SUBJECT: COMANCHE PEAK STEAM ELECTRIC STATION (CPSES)  
DOCKET NOS. 50-446  
TRANSMITTAL OF INSERVICE INSPECTION PROGRAM PLAN  
INTERIM CHANGE REQUEST  
(UNIT 2: 1986 EDITION OF ASME CODE SECTION XI, NO ADDENDA,  
INTERVAL START DATE - AUGUST 3, 1993, FIRST INTERVAL)

Interim Change Request No. ISI-2R0-006

INTERIM CHANGE REQUEST

Plan Title/Rev. Unit 2 ASME Section II Inservice Inspection Program Plan 10 ICR No. 6

CONTAINMENT SPRAY SYSTEM  
SHEET 2 OF 4

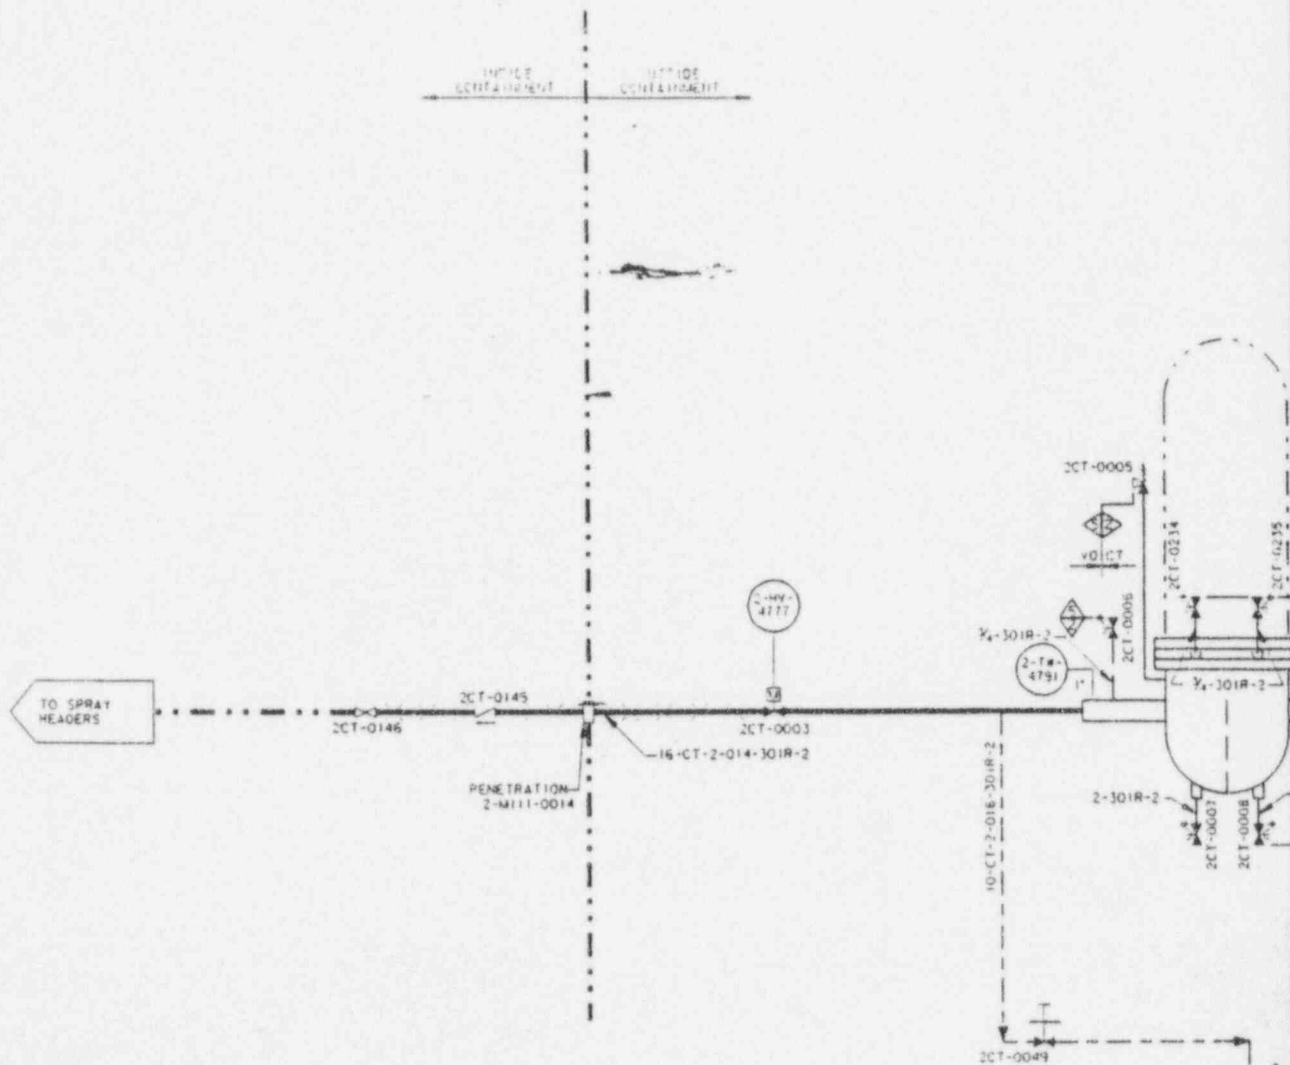
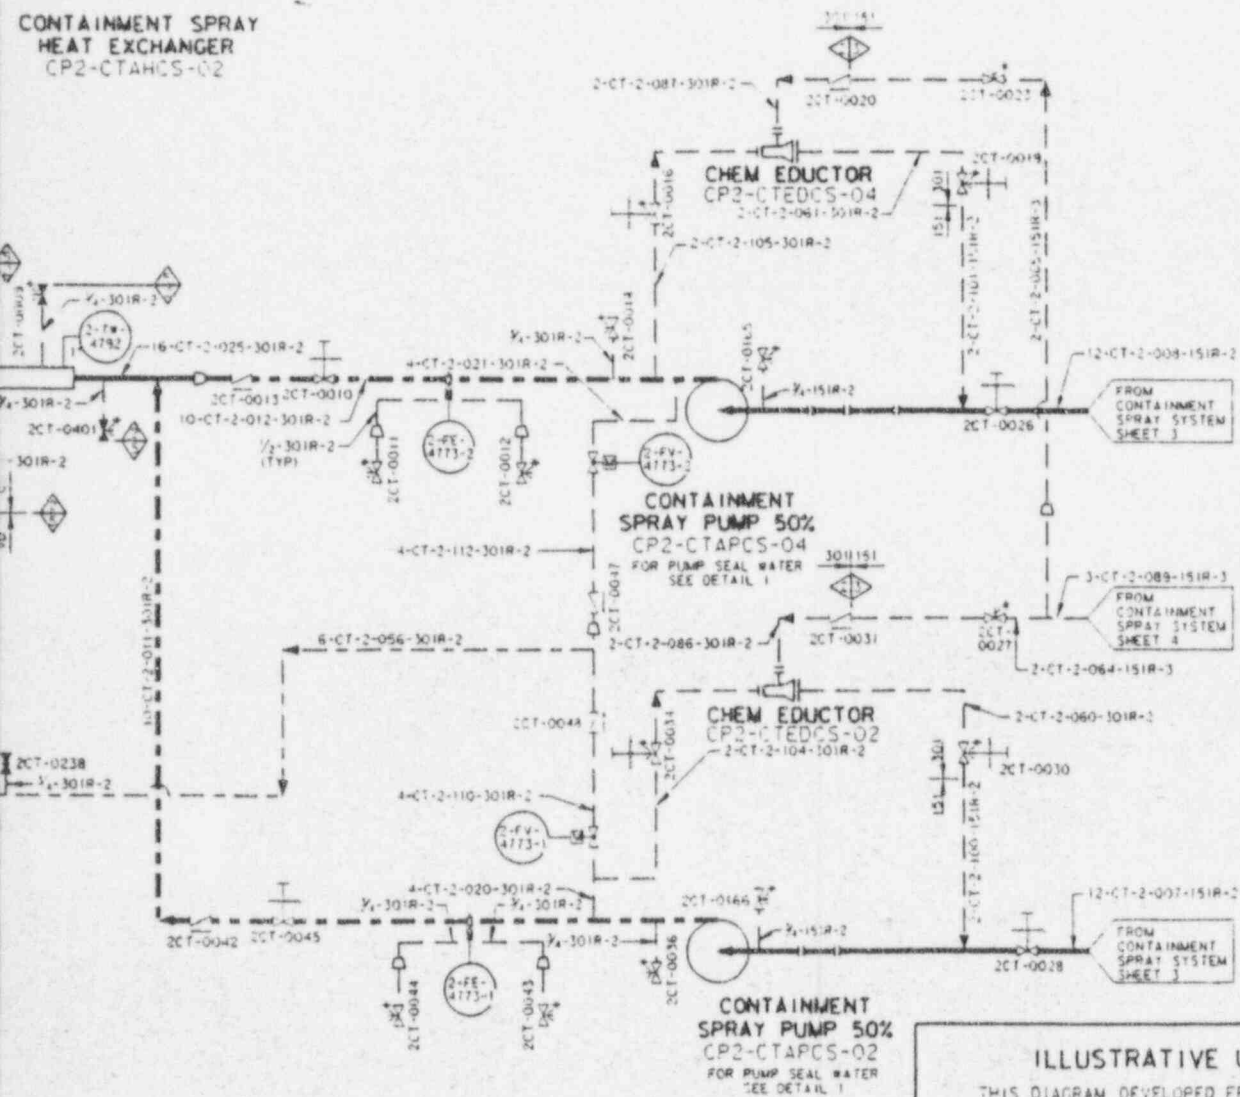
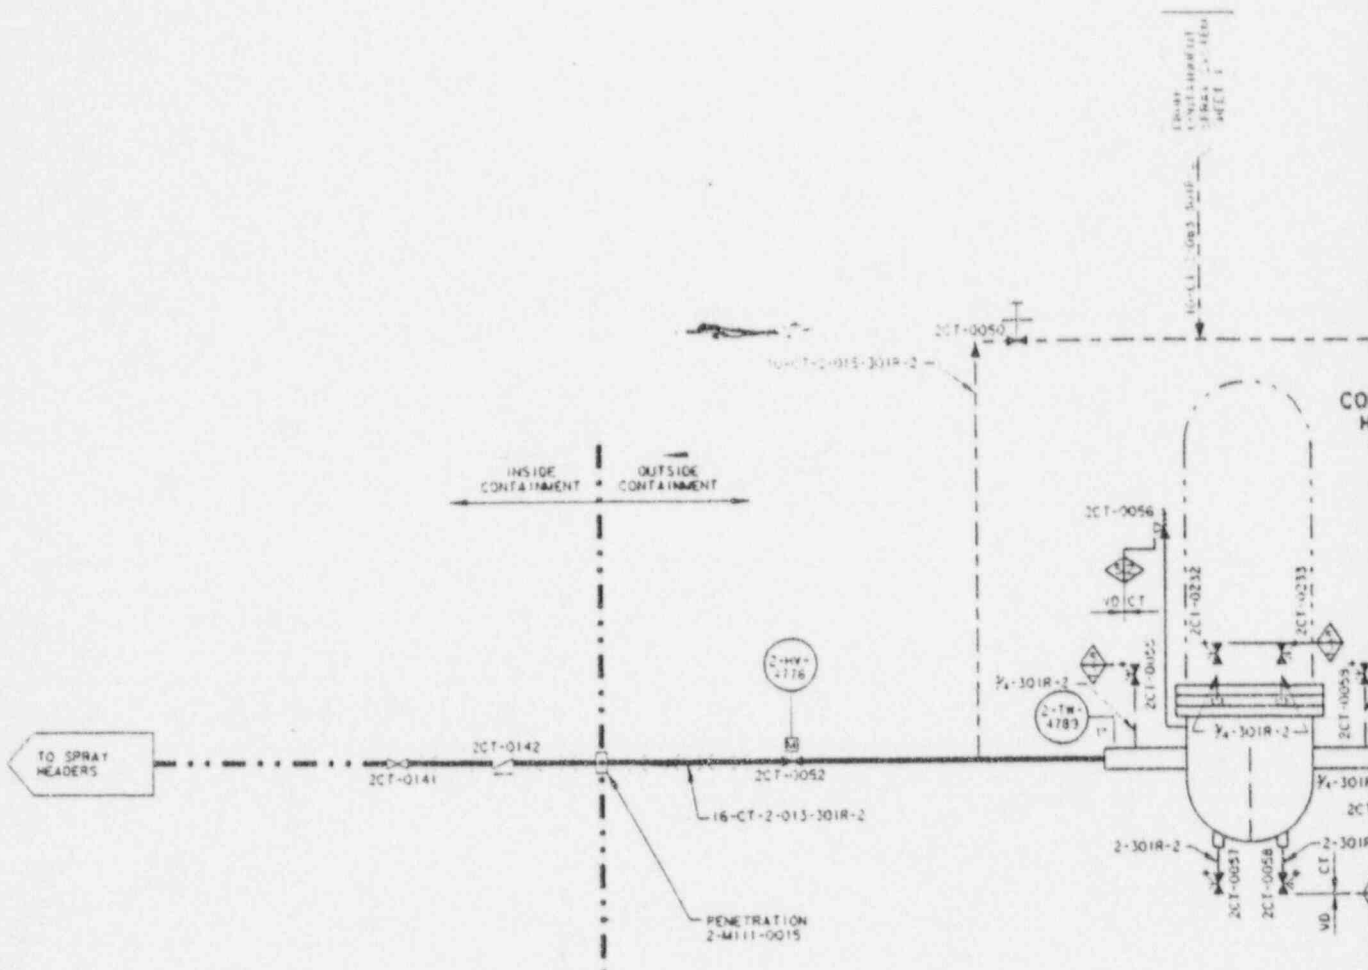
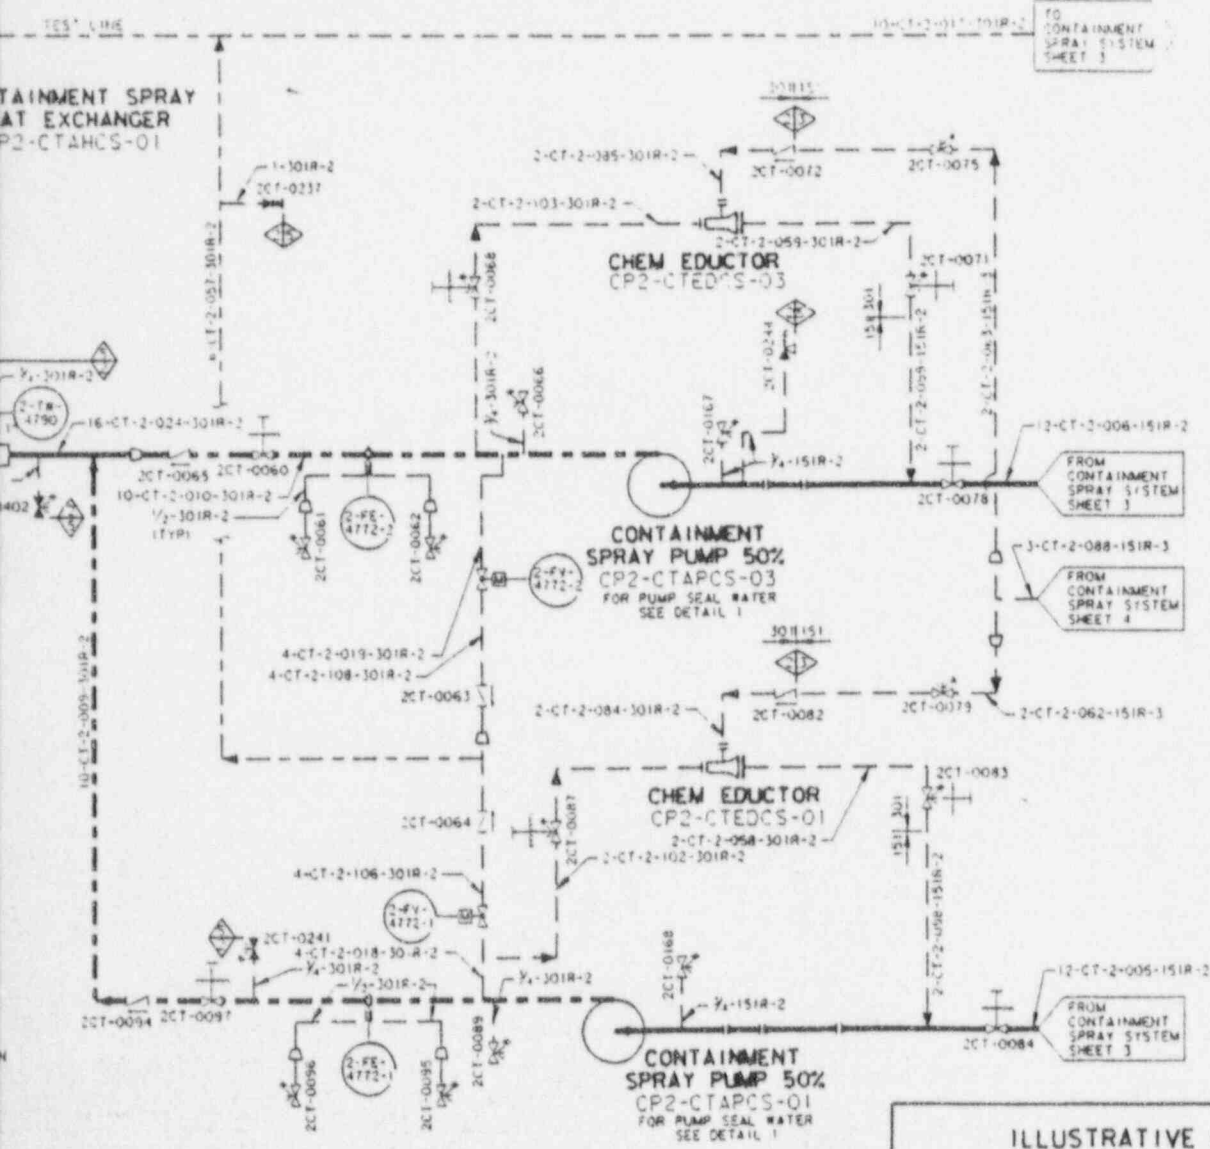
2. CT - The portion of the 16" CT header supply downstream of 2CT-003/052 has been reclassified as ISI only (i.e. removed the pressure test requirements). This is due to the fact that these portions of the CT system are considered as open ended in accordance with Category C-H, note (1). IWA-9000 defines open-ended as, "a condition of piping or lines that permits free discharge to atmospheric or containment atmosphere".

There are 2 valves between 2CT-003/052 and containment atmosphere. However, the manual valve 2CT-0146/0142 is locked open and the other is a check valve (2CT-0145/0142). The valve position of the locked closed valve and the operability of the check valve are periodically verified in accordance with station surveillance procedures.

Replace Table 9 of Section 5.0 with the attached. Replace the existing drawing with the attached drawings as listed below. A detailed justification of this change is attached.
